**North Little Rock Planning Commission**  
**May 14, 2024 - Agenda / Public Hearing 4:00 PM**  
**City Council Chambers – 300 Main Street, NLR, AR 72114**

**North Little Rock Planning Commission**  
**Minute Summary**  
**April 9, 2024**

### SD2024-25 MILLER ADDITION LOT 1 PRE PLAT AND SPR, 8900 HWY 165

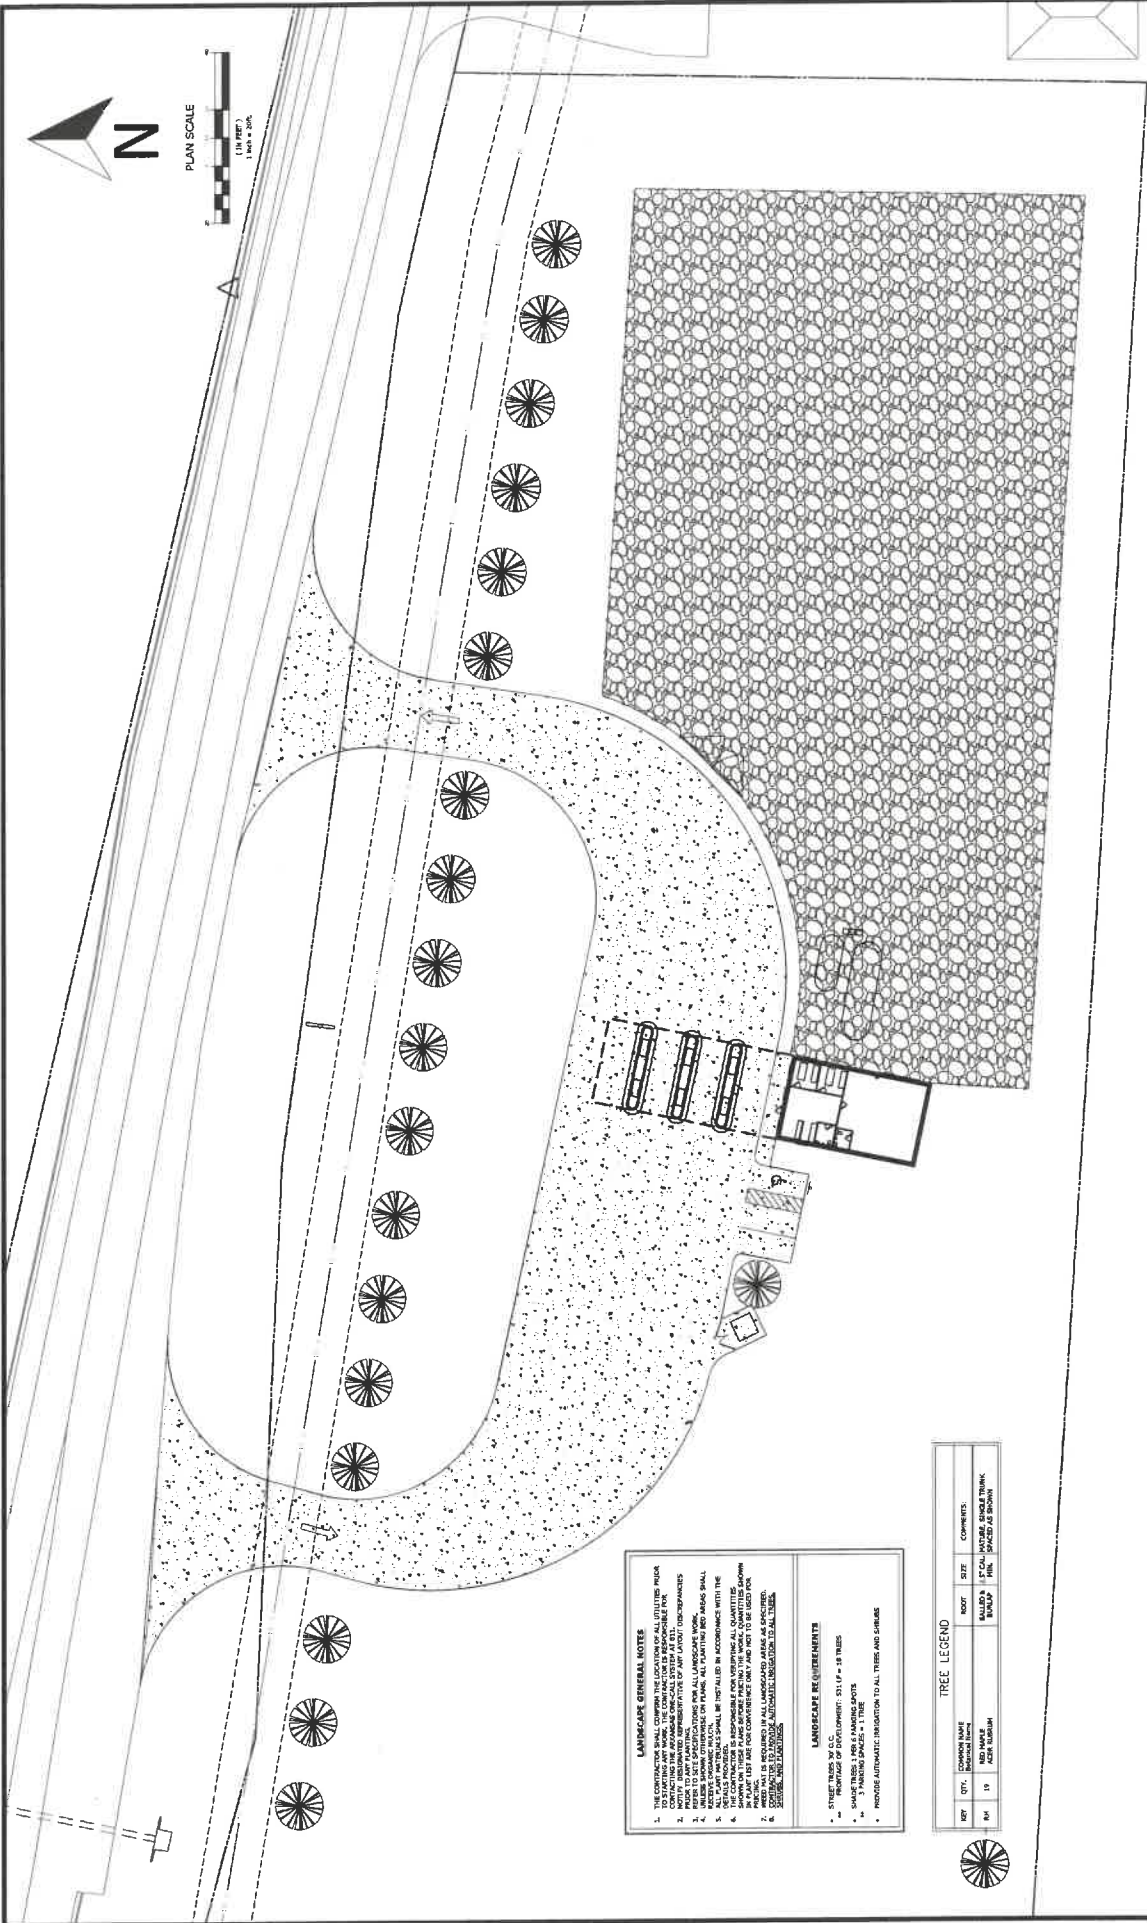
1. Engineering requirements on detention:
  - a. Option to pay the drainage in-lieu of fee of \$5000/acre instead of providing onsite detention.
2. Permit requirements/approvals submitted before a building permit will be issued:

- a. A signed and recorded plat must be on file with the Planning Department.
  - b. Provide CNLR Grading Permit application to City Engineer with grading plans.

- c. Provide CNLR Stormwater Permit application to City Engineer with half size erosion control plan showing silt fence, storm inlet protection, and drainage details.

- d. Provide copy of ARDOT driveway permit.
  - e. Provide CNLR Floodplain Development Permit application to City Engineer.
  - f. Provide copy of Arkansas Department of Environmental Quality (ADEQ) Stormwater Permit to City Engineer.

3. Planning requirements before the plat will be signed:
  - a. Plat will be submitted to NLR Planning Department in CAD compatible DXF and/or DWG format, tied to Arkansas State Plane Coordinates.

- b. Provide street trees or provide a bond.
4. Meet the requirements of Community Planning, including:
  - a. Provide the standard requirements of Zoning and Development Regulations.

- b. Provide dumpster location. Dumpster to have masonry screening on 3 sides along with an opaque gate enclosure.
  - c. No fence is to be in front of the building.

- d. All exterior lighting shall be shielded and not encroach onto neighboring properties.
5. Meet the requirements of the Master Street Plan, including:

- a. Provide 5' sidewalks and ramps with a minimum of 5' green space between sidewalk and curb to ADA standards and City standards.
  - b. Provide ½ street improvements.

- c. Provide ROW dedication.
6. Meet the requirements of the Screening and Landscaping ordinance, including:
  - a. All disturbed areas are to be sodded, fertilized, watered and mulched.

- d. Trees shall be planted at one (1) tree per six (6) parking spaces.
    - i. Parking lot trees are to be chosen from Table B or C, Section 7.5 of the North Little Rock zoning code, Table D shall be used if beneath overhead power lines.

- e. Landscape plans to be revised prior to the May 2024 Planning Commission Hearing.
7. Meet the following requirements concerning signage:
  - a. Provide the location of the proposed sign on the site plan.

- a. Provide an approved fire protection plan.
  - b. Meet the requirements of the 2021 Arkansas Fire Prevention Code including:
    - i. There shall be a fire hydrant within 400' of any portion the building if unsprinklered, within 600' if sprinklered. (Volume 1 Section 507.5.1)

- b. If septic is used provide a copy of the approval from the AR Dept. of Health with the building permit application.
